Access Compliance Report

Public Rights-of-Way

(Curb Ramps)

Intersection ID: 43360	Main Street: HIGHLAND_COMMONS_RD	Cross Street: RIDGEVIEW_COMMONS_DR	Location:	N
ADA ID: 31EB4EC88C1C	Ramp Type: BlendTrans1	Initial Pass/Fail: Pass	Overall Compliance: No	Severity Score: 7.75
Codes/Mitigation Info/Possible Solution		Field Measurements/Component Compliance

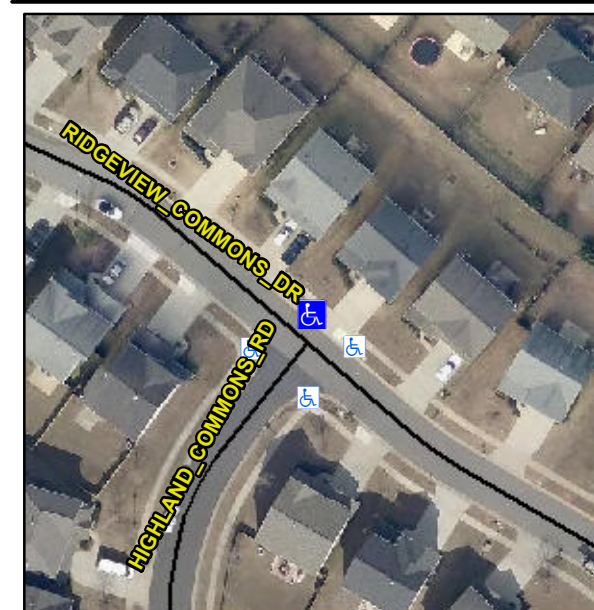
Not Found, R304.2.1, R302.7.2

N/A	Ramp inside XWalk1?	N/A	N/A	Ramp inside XWalk2?	N/A
	Road Slope (%)	3.0		Clear Space?	Yes
	Road X Slope (%)	1.2	N/A	Clear Space to XWalk (in)	N/A
Yes	Any Obstructions?	No	Yes	Storm Grate/Utility Hazard?	No
	Obstruction Type			Storm Grate/Utility Type	
		N/A			N/A
			Yes	Surface Condition? (G/P)	Good
			No	Curb Slope (%)	12.9

Remove & Replace Curb Ramp With Two New Directional Ramps or Equivalent.
